Riverside Energy Park

Statement of Common Ground: Environment Agency (Signed)

8.01.11

Statement of Common Ground between the Applicant and The Environment Agency

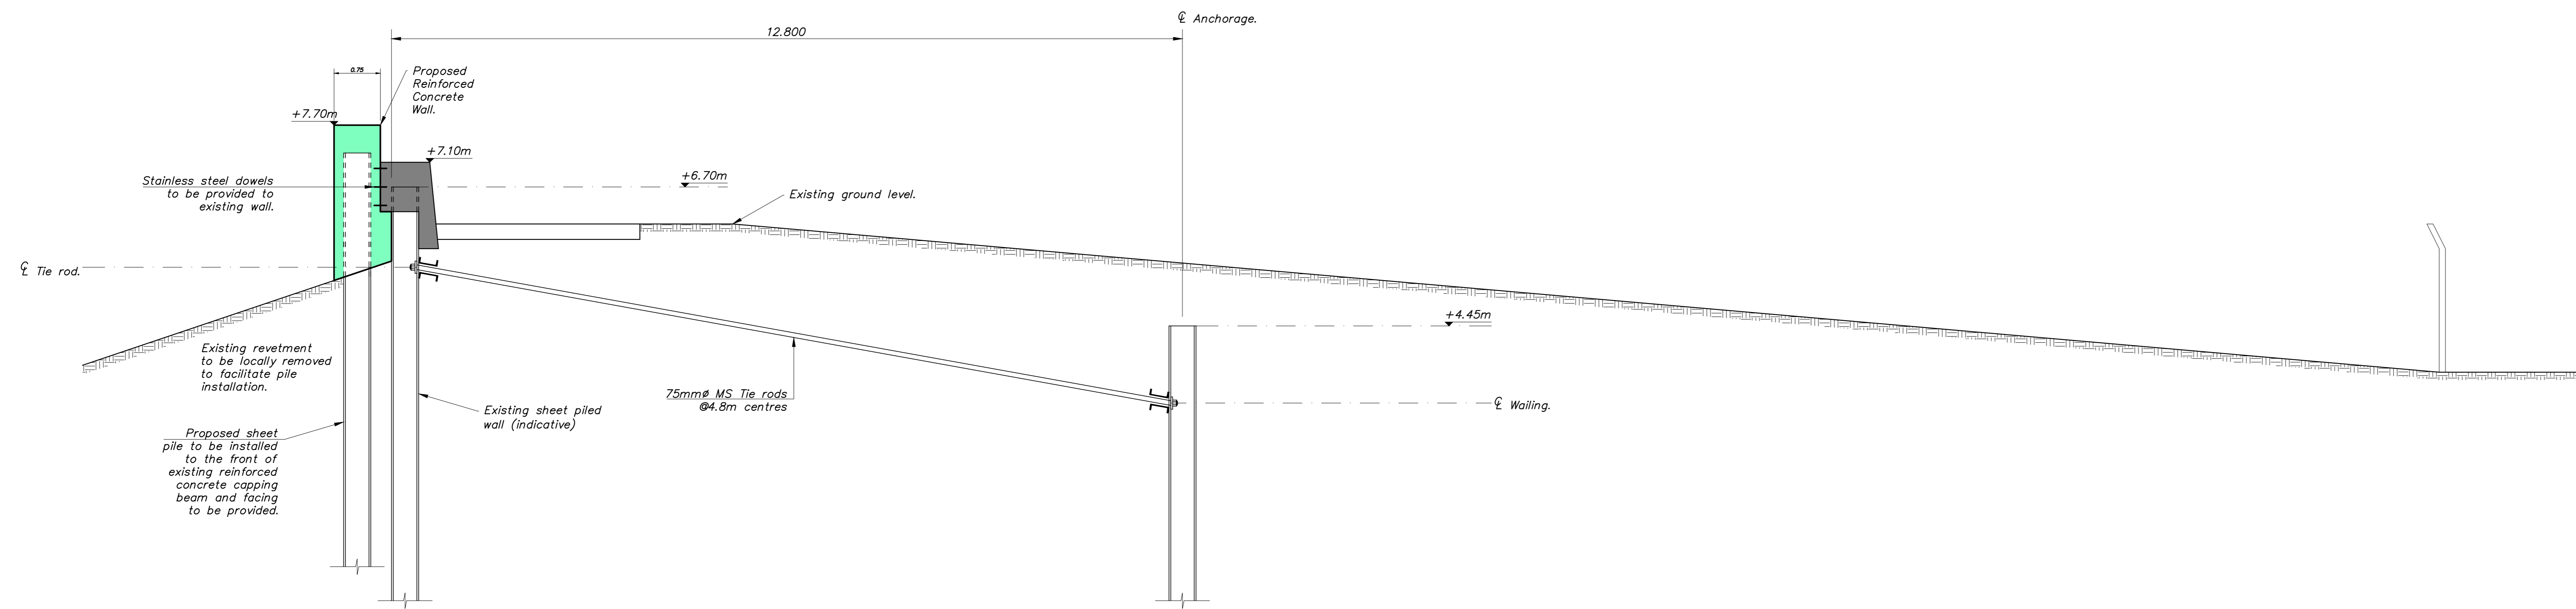
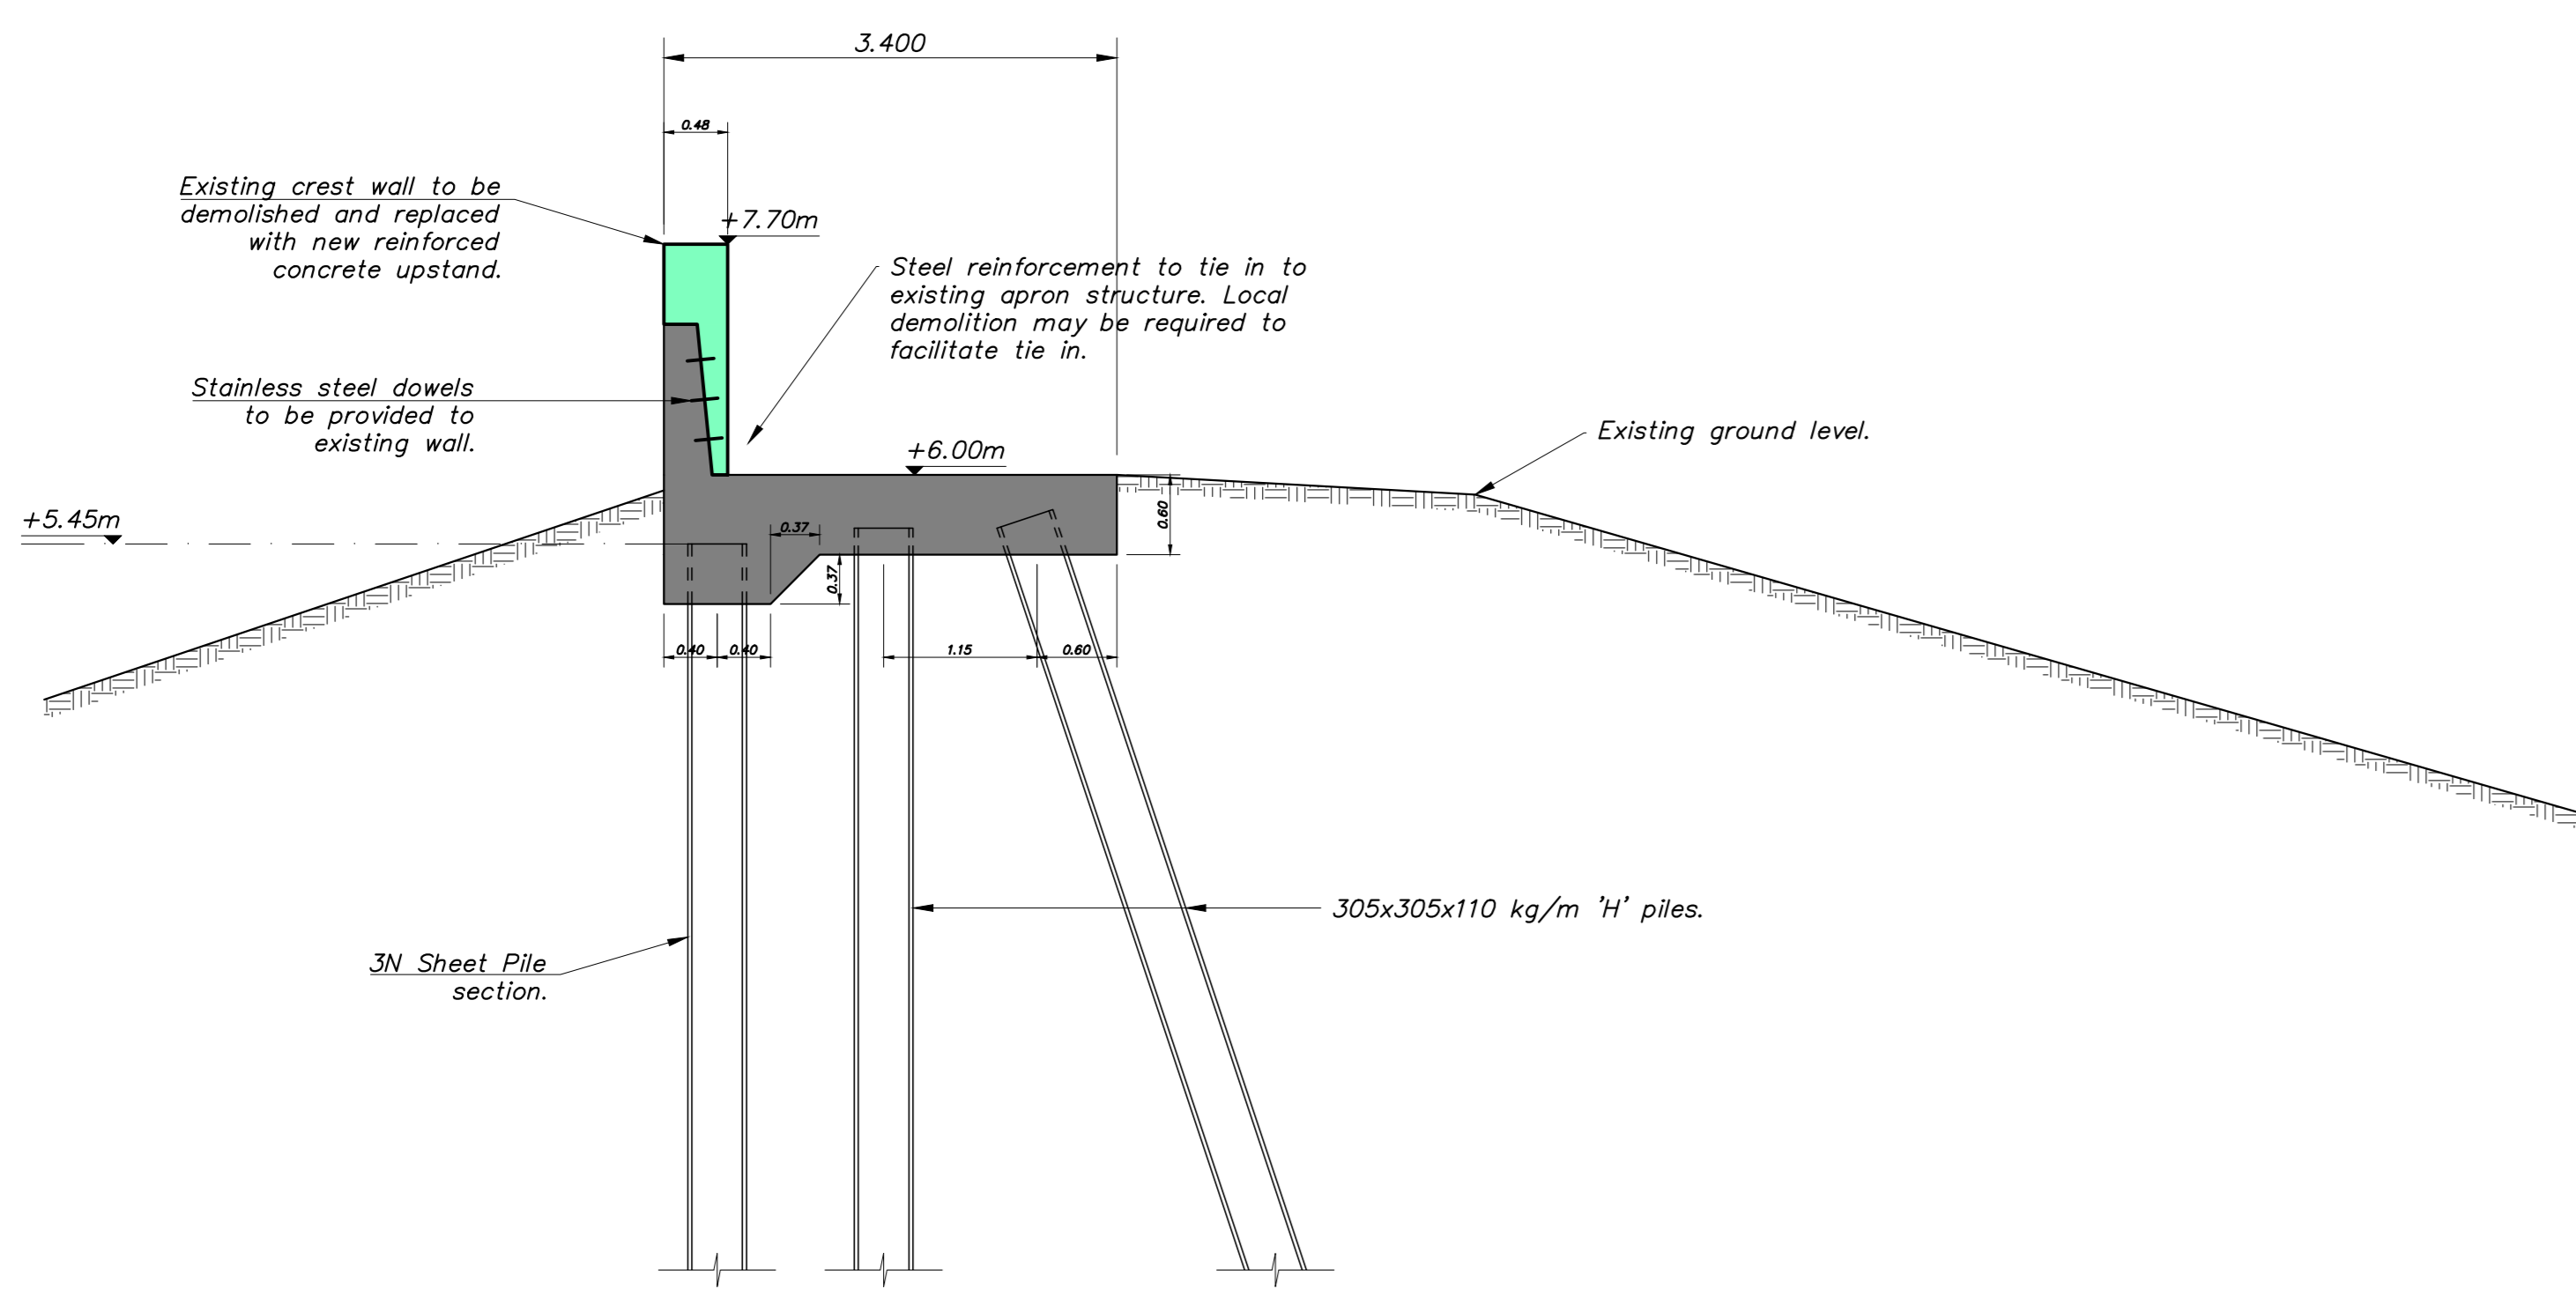
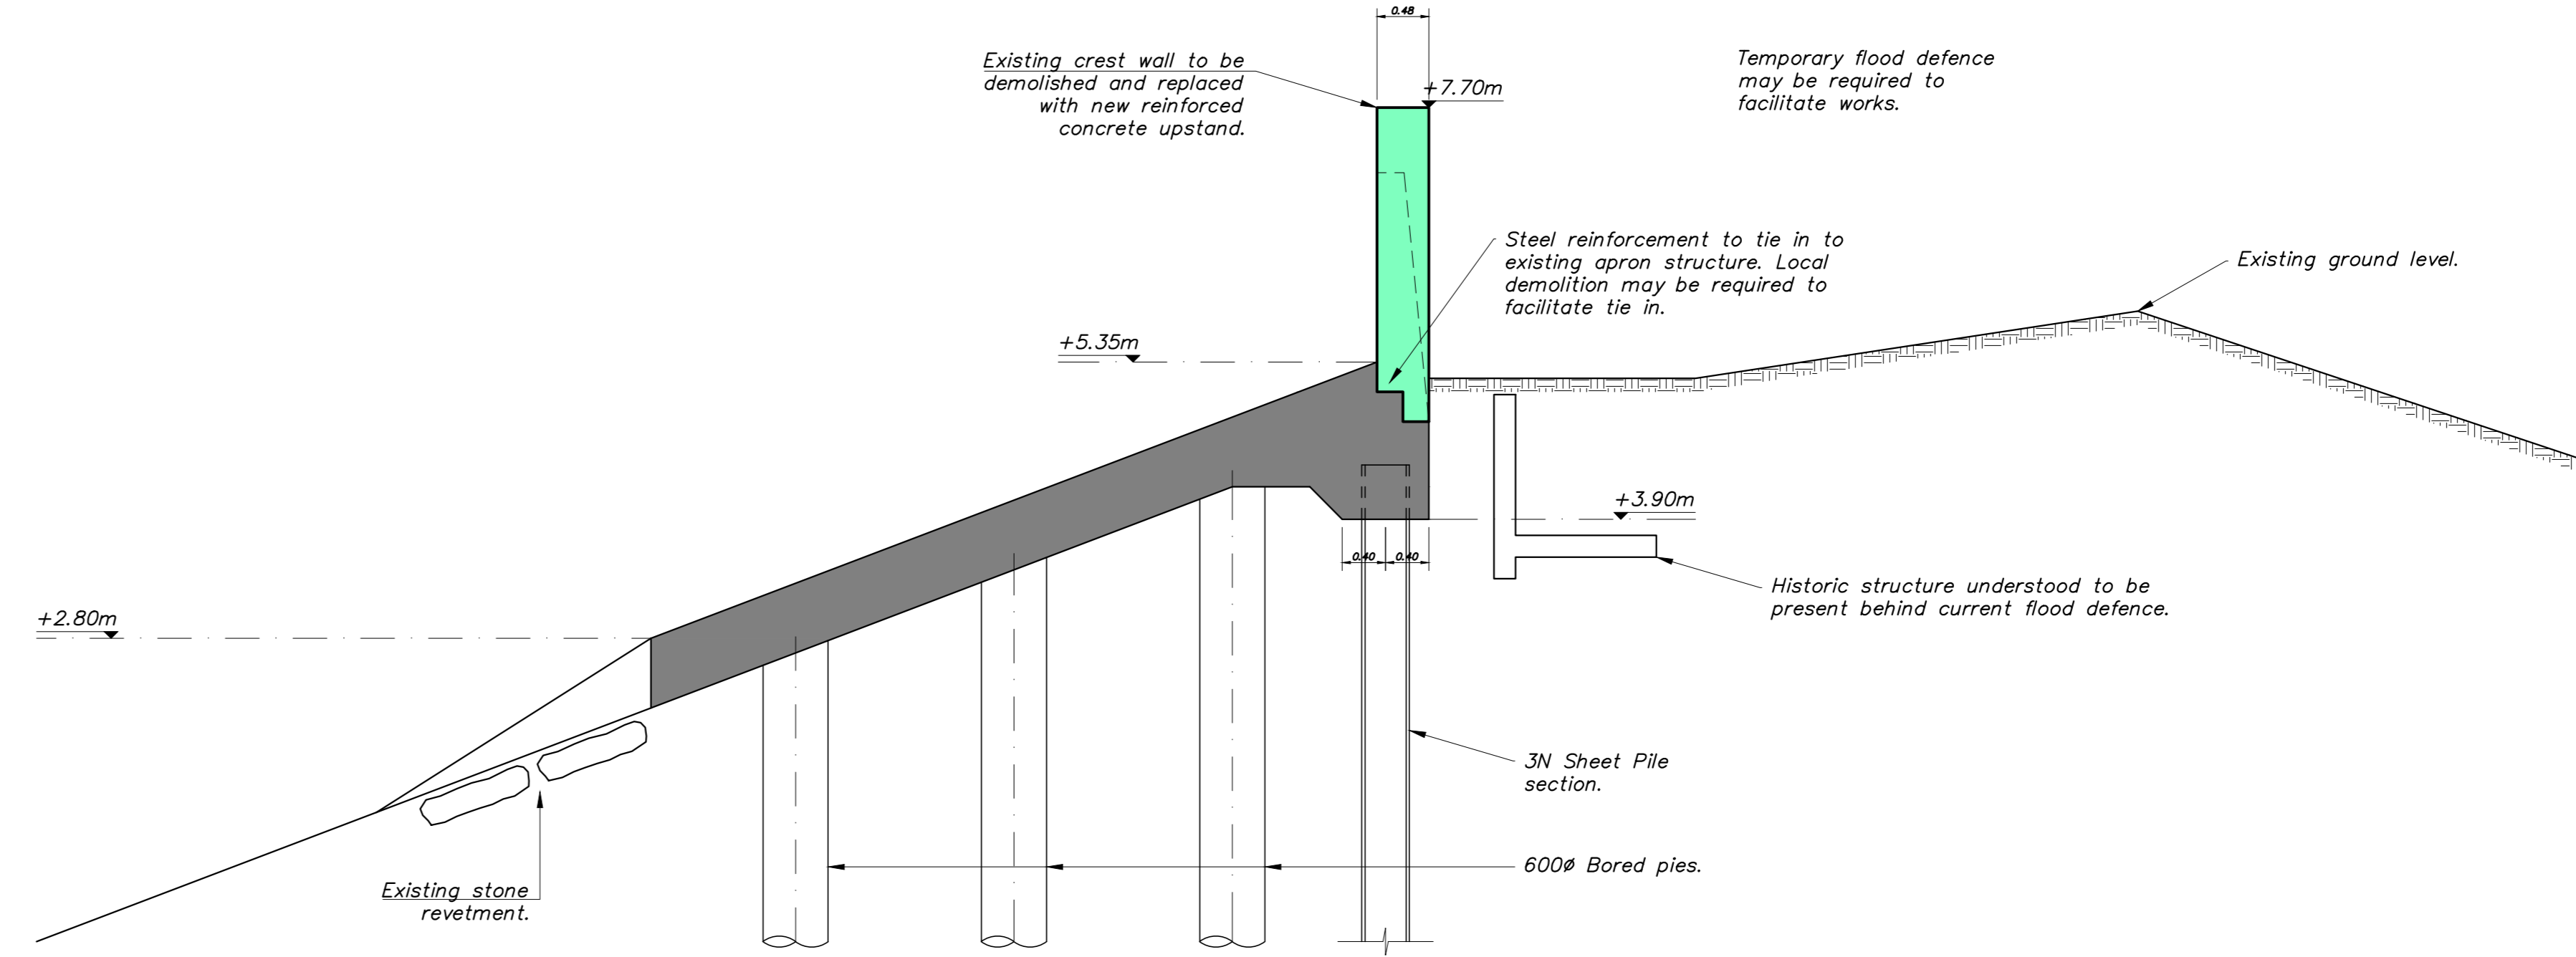
2.2.1 Through the indicative diagrams C110-113 (see **Appendix A** of this SOCG), the Parties agree that it has been demonstrated that the Proposed Development does not preclude the raising of the flood defence to the second stage level (of 7.7m AOD expected in 2070) proposed in the Thames Estuary 2100 Plan, and does not significantly restrict future defence raising options. These illustrative drawings were provided at the request of the EA in order to provide examples of technical solutions that could be adopted in the future should the need ever arise to raise the flood bank in line with the requirements of the Thames Estuary 2100 Plan.

Date	13.05.19
A1 Scale	1:750
Drawn by	AG
Checked by	PC
Drawing Number	VAA-WA-50080100_1.0

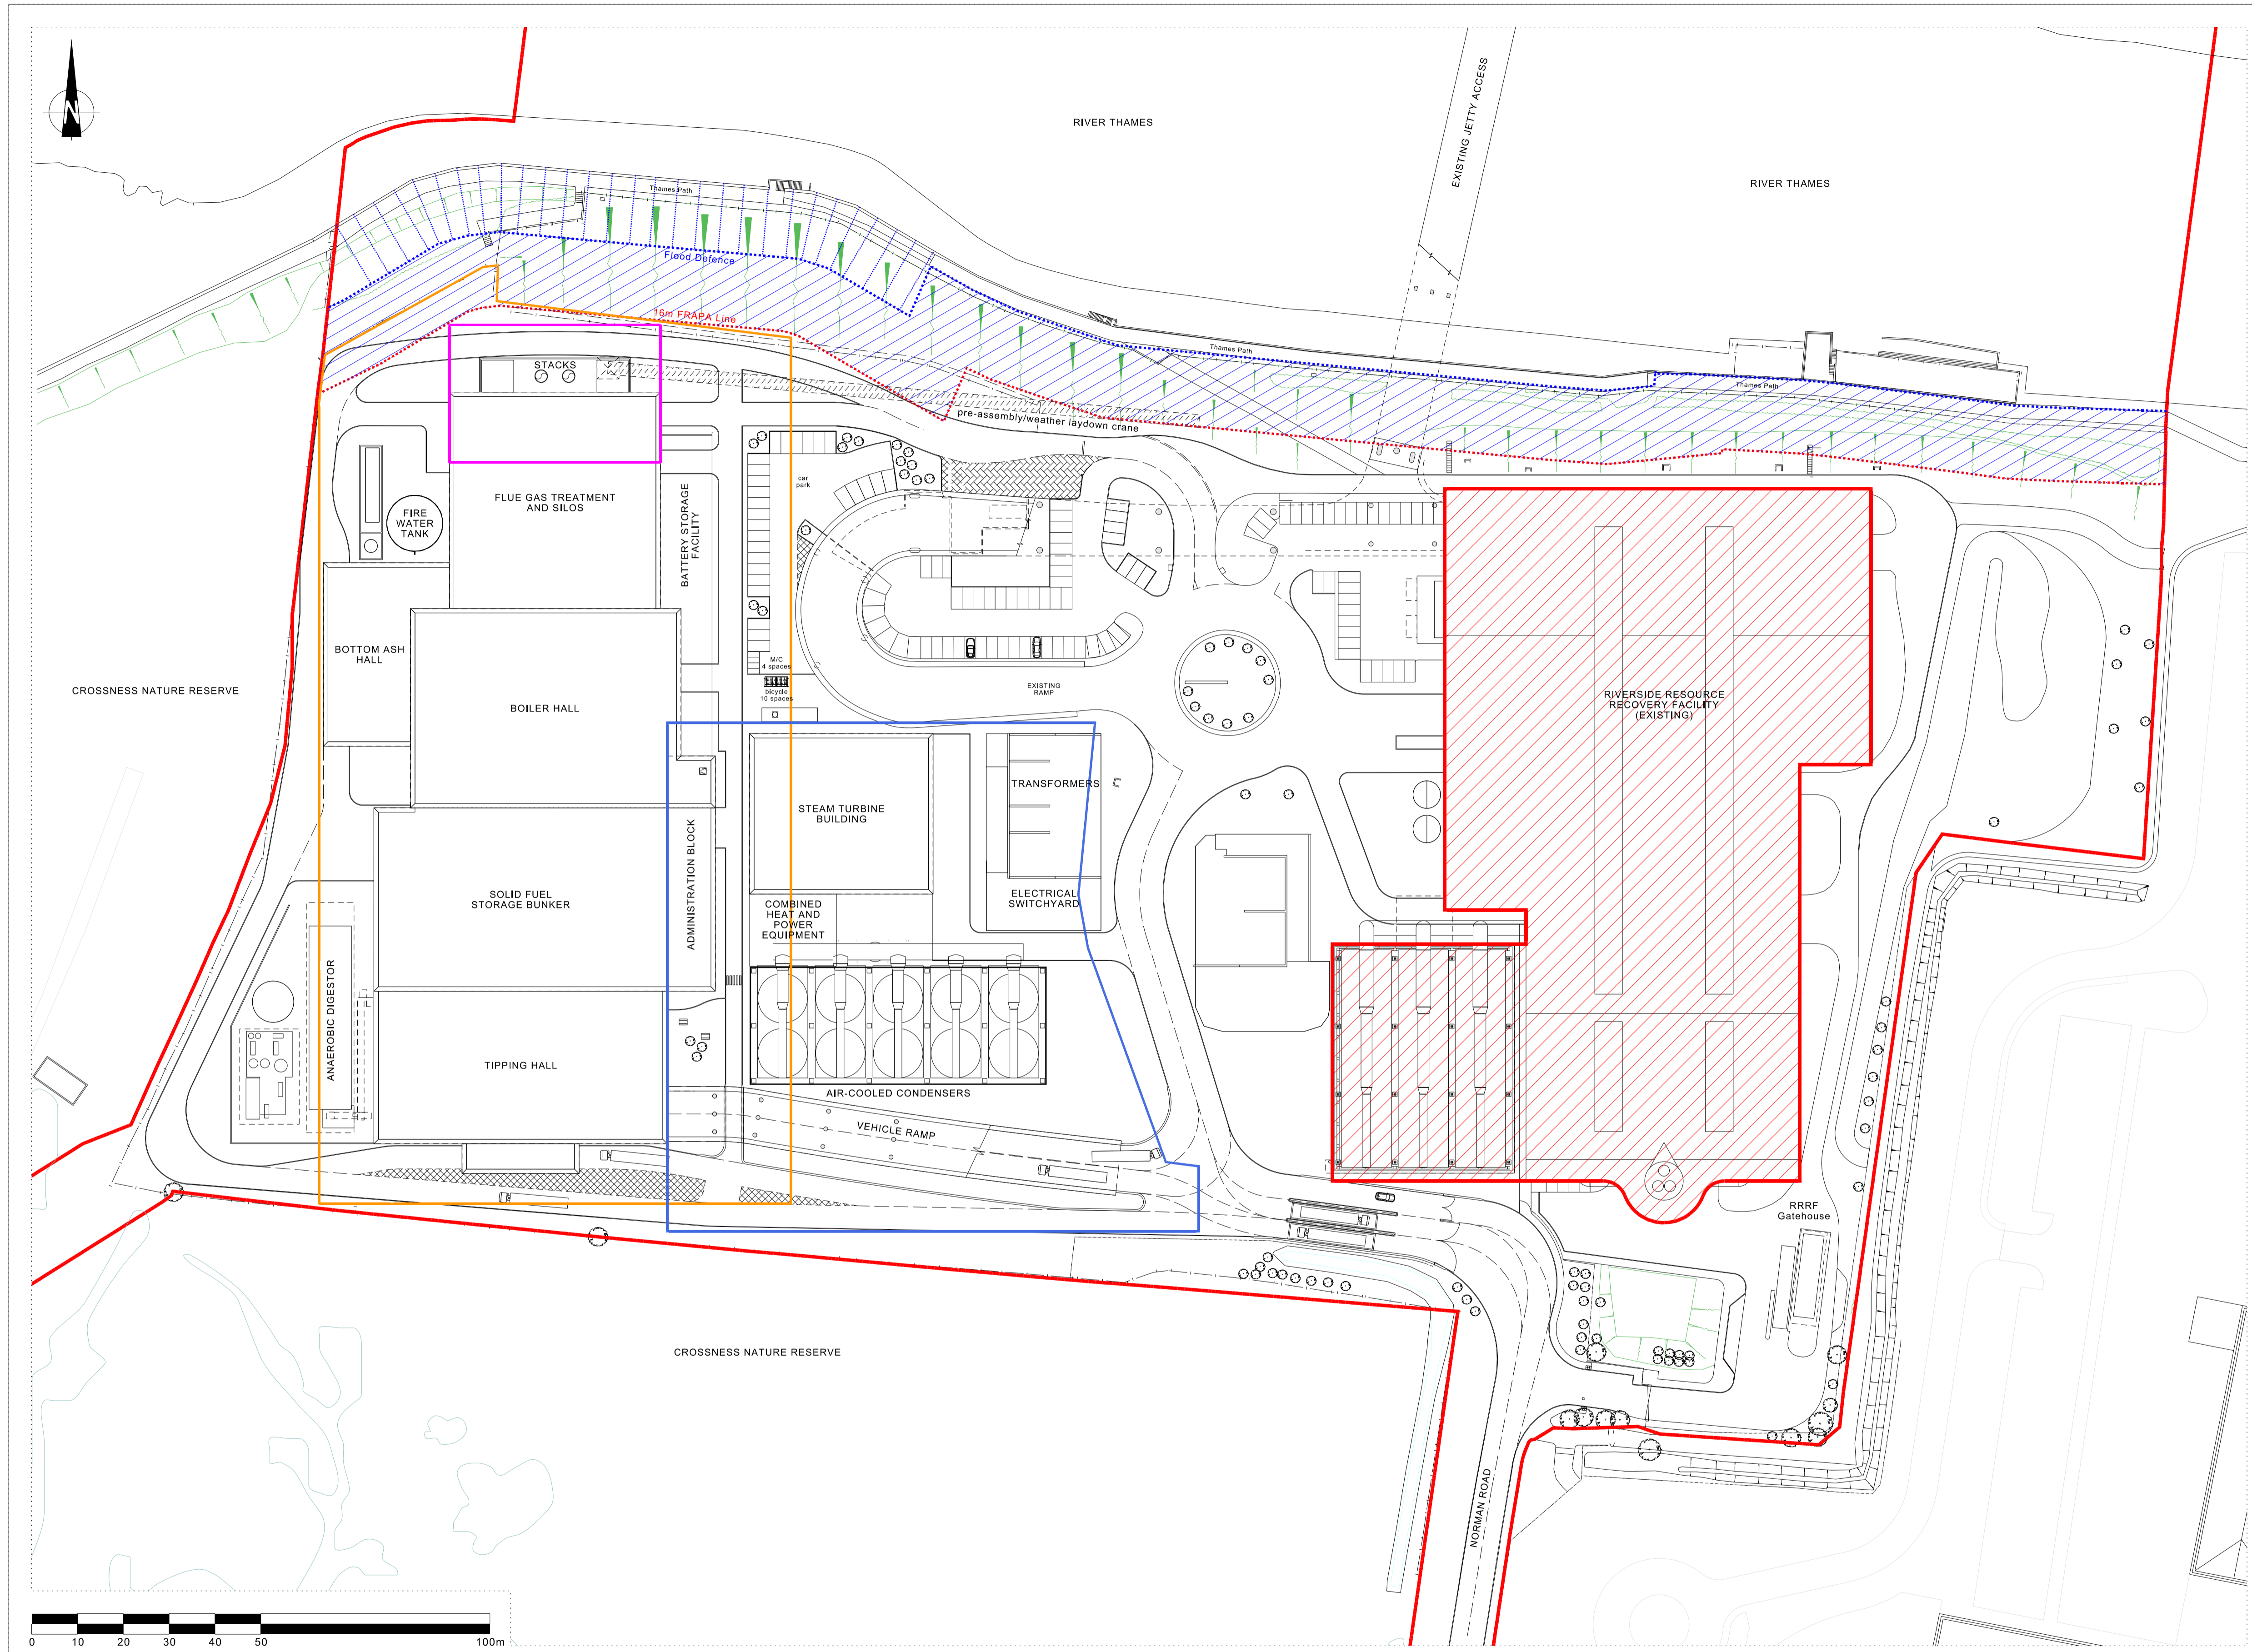
2.3.1 The Flood Risk Activity Permit Area (FRAPA) for REP is shown in diagram VAA-WA-50080100_1.0, VAA-WA-50080110_1.0 and VAA-WA-50080101_1.0 appended to this SOCG (see **Appendix B**).
